Alabama Port Authority

Project Name Choctaw Point Container Terminal – Phase V Dock Extension

ADDENDUM NO. 2

**11411- Task 6 – Choctaw Point Container Terminal – Phase V Dock
Extension
Contractor Questions**

CLIENT DWG NO:
**CHOCTAW POINT CONTAINER TERMINAL
PHASE V DOCK EXTENSION
W.S. & L.S. STOWAGE PIN POCKET DETAILS**

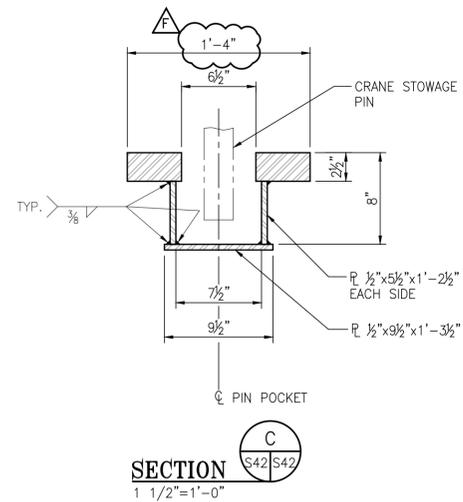
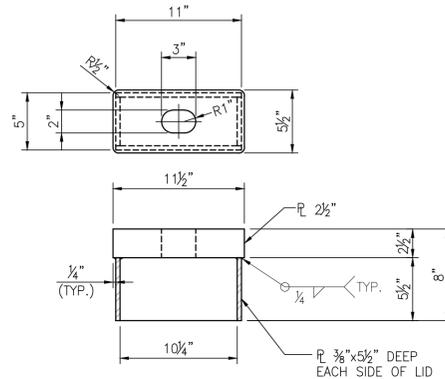
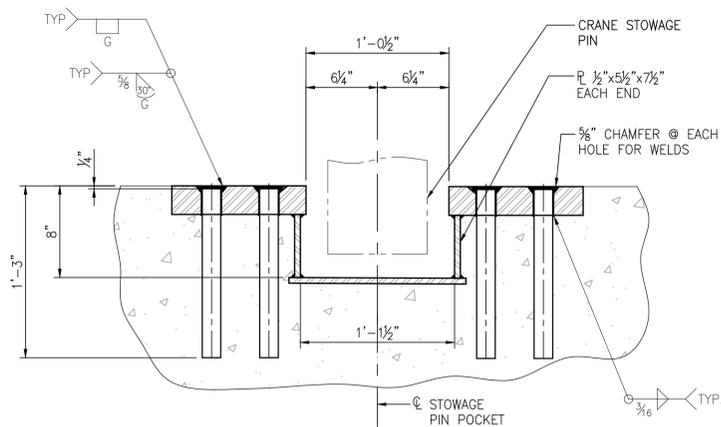
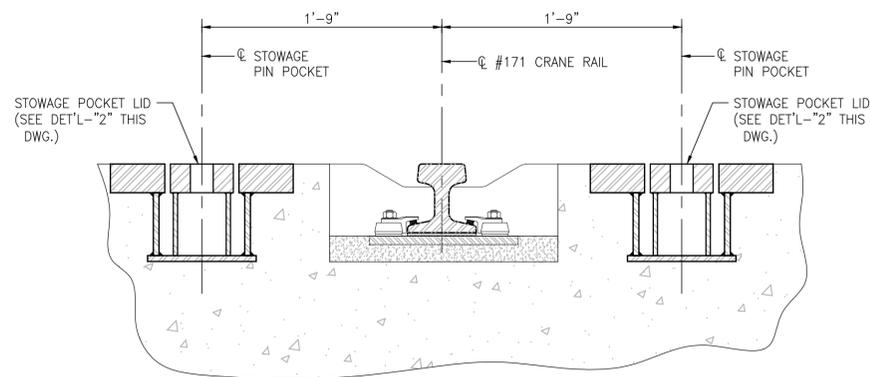
F	ADDENDUM 2 - CHANGED PL 2 1/2" LENGTH & WIDTH DIMENSIONS	RST	MED	RSG	03-05-26
E	ISSUED FOR BID	RST	MED	RSG	01-14-26
D	100% DESIGN REVIEW	RST	MED	RSG	09-09-25
C	95% DESIGN REVIEW	RST	MED	RSG	08-08-25
B	60% DESIGN REVIEW	RST	MED	RSG	06-10-25
A	30% DESIGN REVIEW	ECW	JEJ	RSG	04-11-25
NO.	REVISION	DRAWN	CK'D	APPD	DATE

CHOCTAW POINT CONTAINER TERMINAL
 PHASE V DOCK EXTENSION - DEMOLITION PACKAGE
 EXISTING SITE PLAN

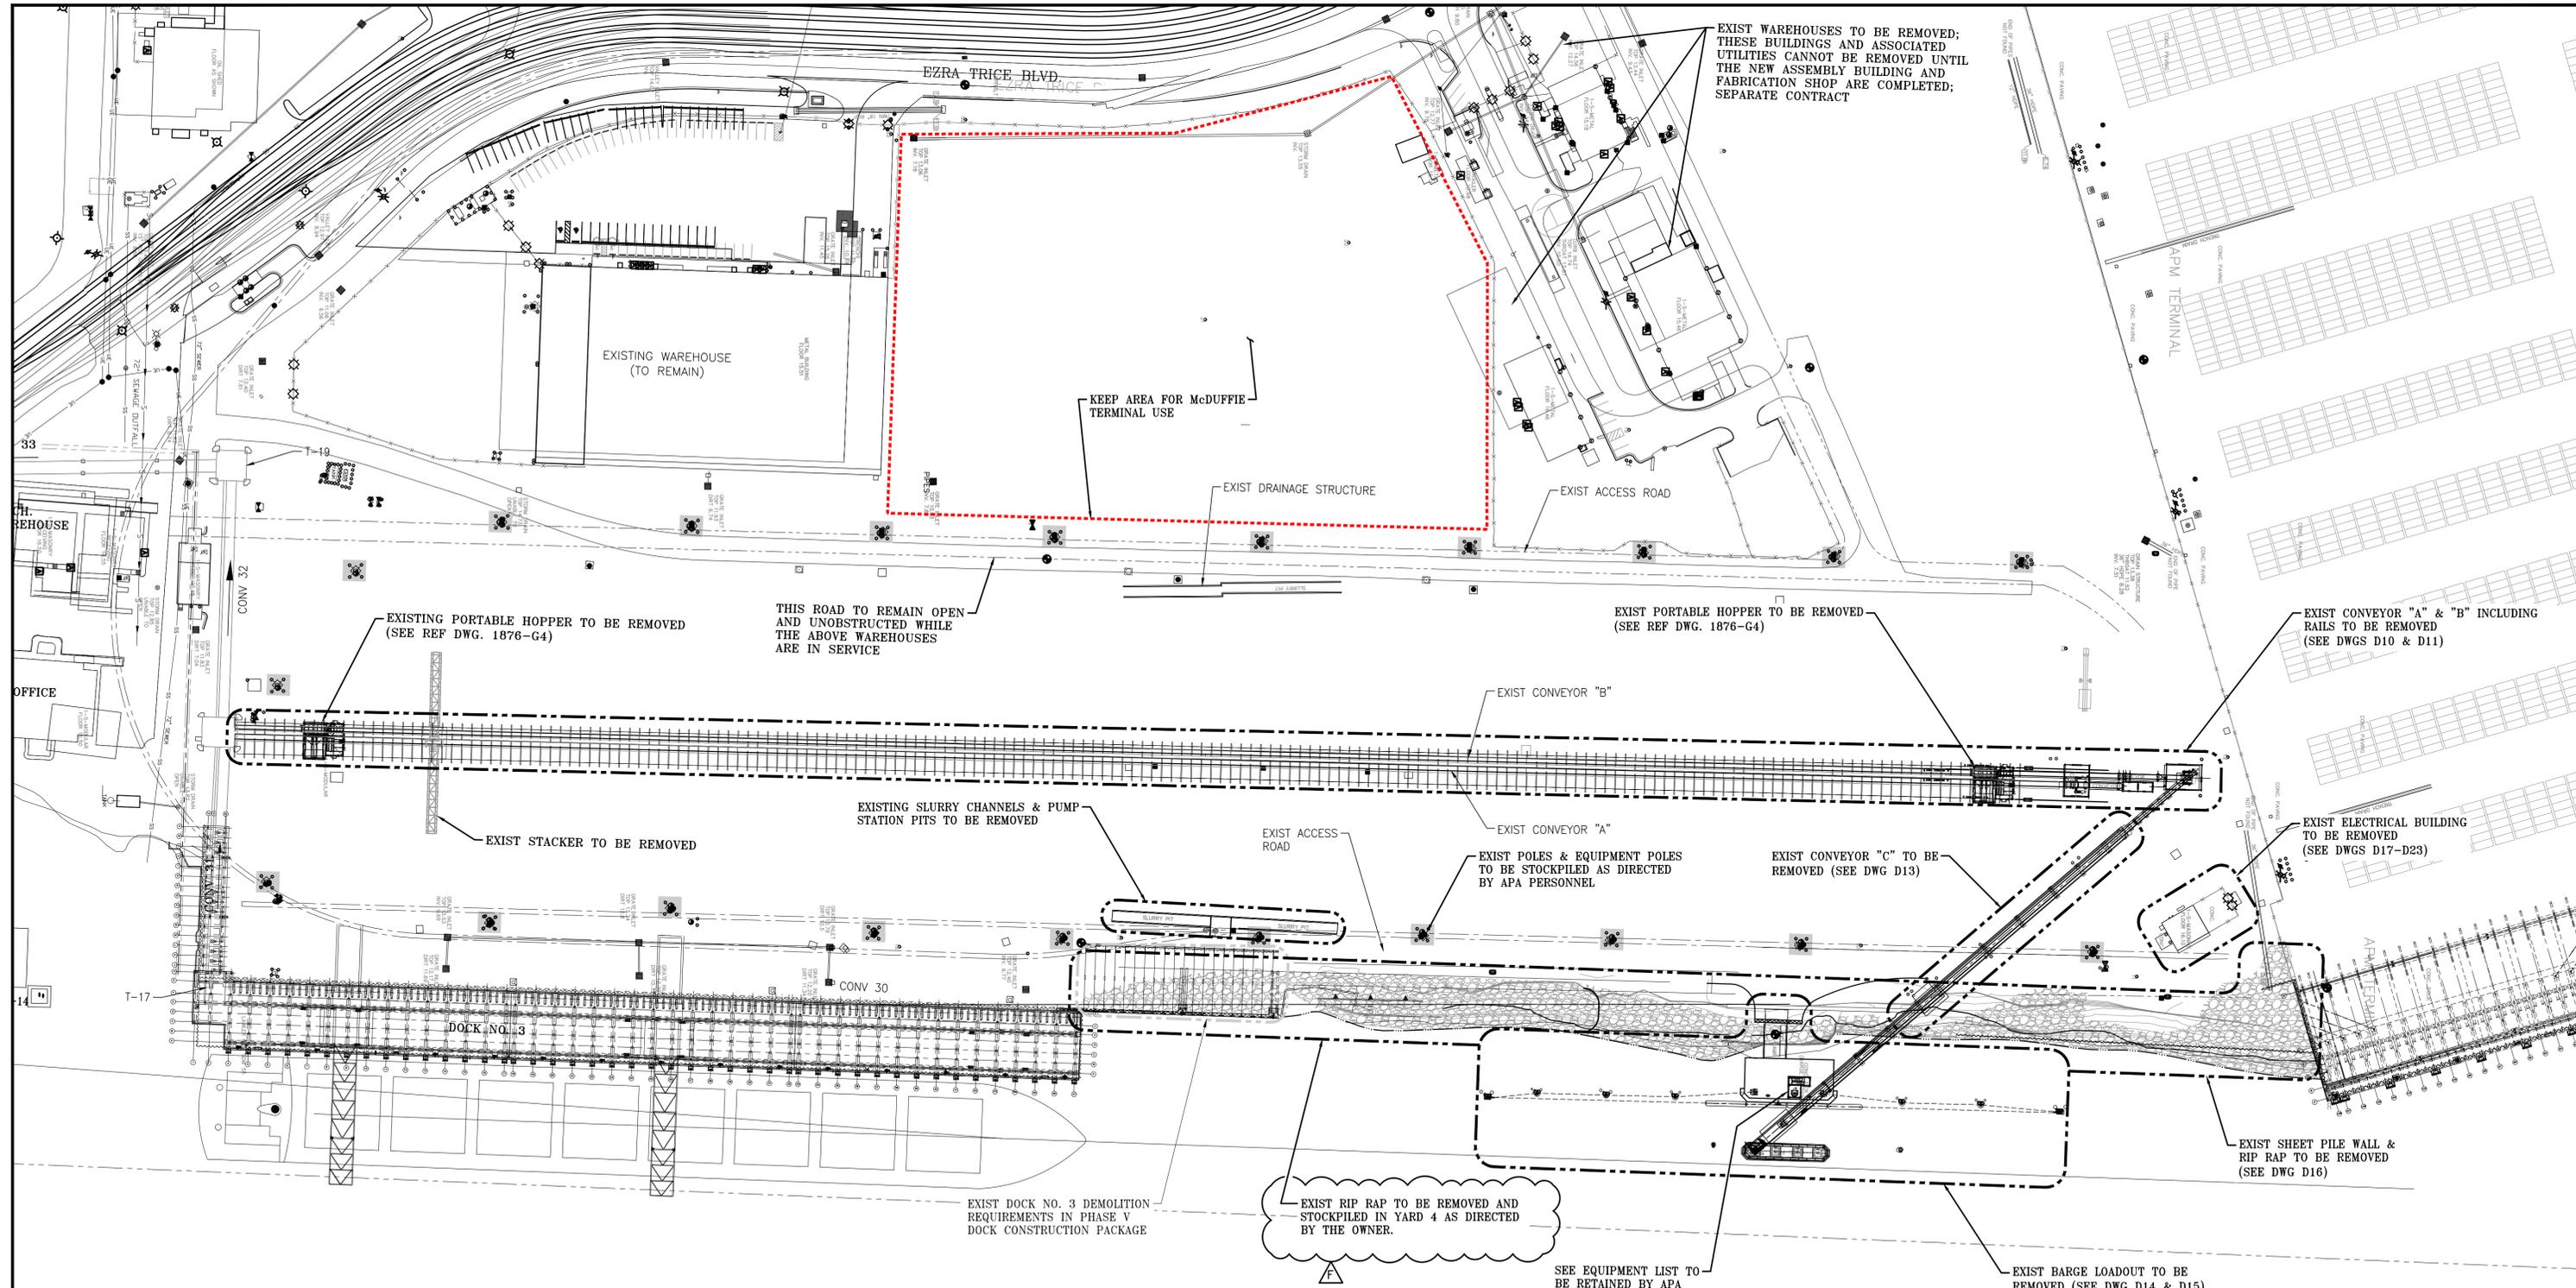
NO.	REVISION	DATE	APPD	CK'D	DRAWN	DATE
F	ADDENDUM 2 REVISED NOTE	03-11-26	RST	JEU	RSG	03-11-26
E	ISSUED FOR BID	01-14-26	JLH	JEU	RSG	01-14-26
D	100% DESIGN REVIEW	09-09-25	ECW	JEU	JLH	09-09-25
C	95% DESIGN REVIEW	08-08-25	JLH	JEU	RSG	08-08-25
B	60% DESIGN REVIEW	06-10-25	ECW	JEU	RSG	06-10-25
A	30% DESIGN REVIEW	04-11-25	ECW	JEU	RSG	04-11-25

DRAWING TITLE
MSB-100 BOLLARD PLANS

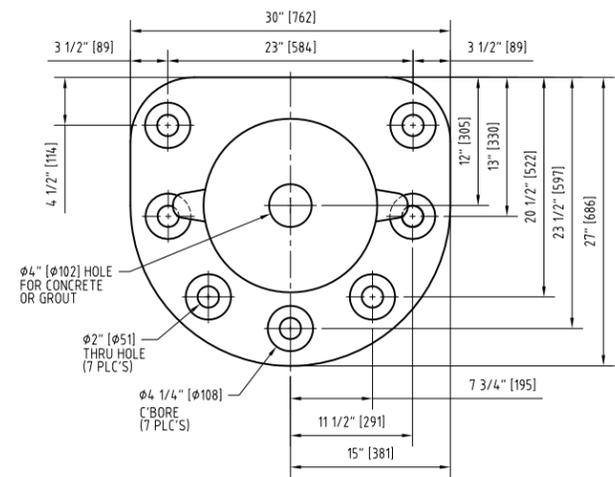
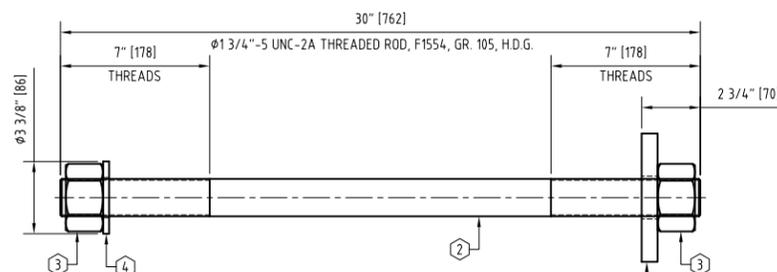
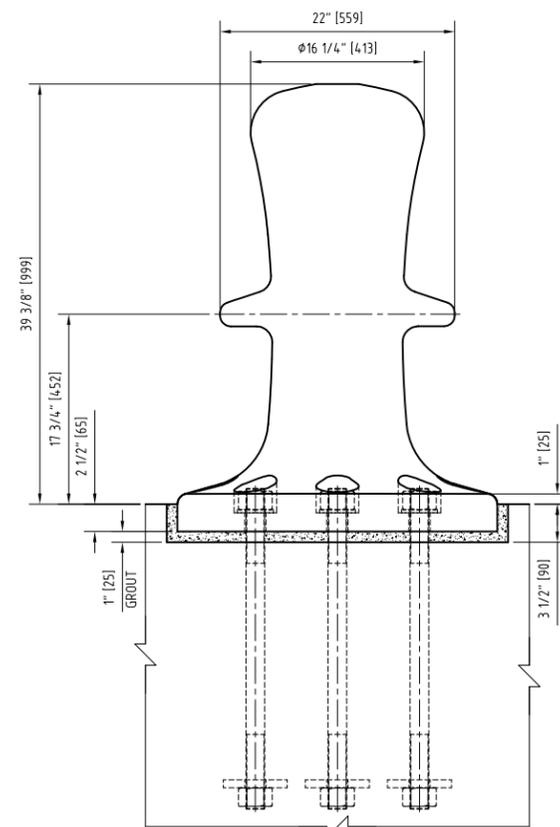
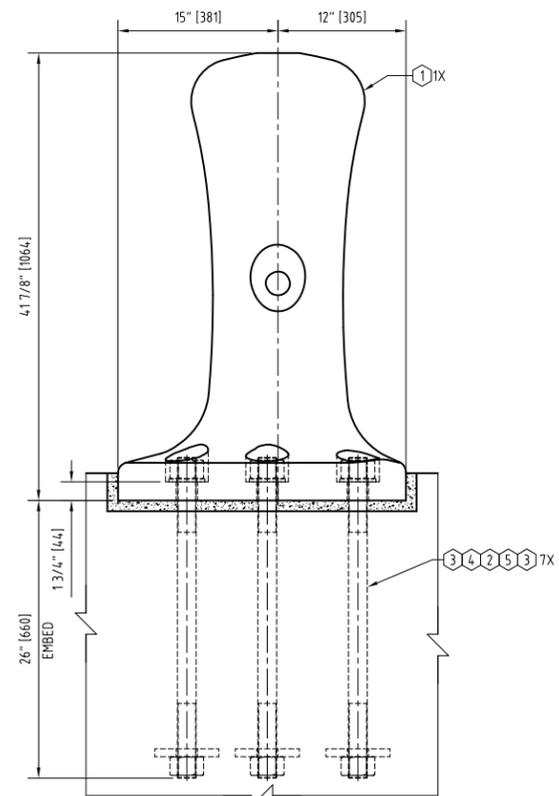
9. Will the attached 100 and 250 ton single bitt bollards from Trelleborg be approved as bollard alternatives?
 - We take no exception to the submitted bollards (Trelleborg Drawings MSB-100 and MSB-250 Bollard Plans (pages 1 & 2) attached)
